DEPARTMENT OF TRANSPORTATION

49 CFR Part 571

Federal Motor Vehicle Safety Standards; Lamps, Reflective Devices, and Associated Equipment

ACTION: Final rule; response to petitions for reconsideration.

FIGURE 14

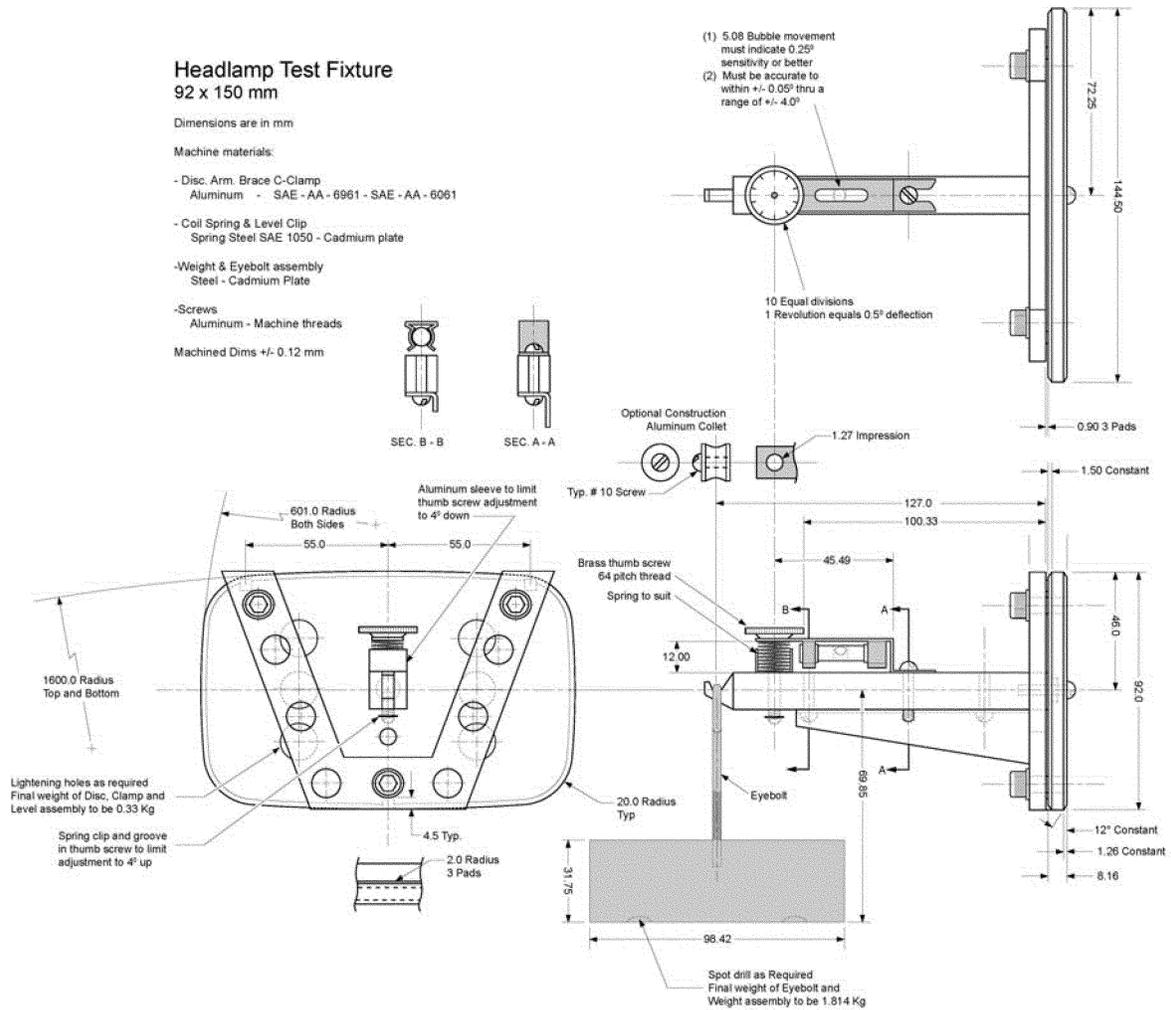
The Associations claimed that the final rule had an error in Figure 8, “Replaceable Light Source Detection Test Setup,” and requested that dimension “A” be replaced with the term “Light Center Length.” The Associations also requested that Figure 14 be changed. They stated that the material specification for the “Disc. arm Brace & Clamp” should appear as “SAE–AA–6061 T6 or equiv,” and the “Coil Spring and Level Clip” should appear as “Spring Steel SAE 1858–Cadmium Plate.” Also, they stated that in Figure 14, “5.00 Bubble movement” should be replaced by “5.88 Bubble movement” and the screw “Typ. #18” should be “Typ. #10.” Finally, in Figure 14, the Associations suggested that the dimension of “100.33” should instead be “188.33.”

The Associations also requested changes to Figure 14 that include changing the “Disc. Arm and Brace Clamp” material from SAE-AA-6961 to SAE-AA-6061. The agency agrees that this was listed incorrectly and has modified Figure 14 accordingly. They also requested that the “Coil Spring and Level clip” material be changed to “Spring Steel SAE 1858—Cadmium Plate.” The agency does not agree as “Spring Steel SAE 1050” is called out in the currently applicable version of this standard. Therefore, we are denying this request. Also, the agency has corrected the value of the bubble movement to 5.08 and changed the screw number to “TYP #10” in Figure 14 because these changes are consistent with the currently applicable version of the standard. The dimension of 100.33 was correctly translated from the currently applicable version of the standard so the agency is denying the Associations’ request to amend that value to 188.33.
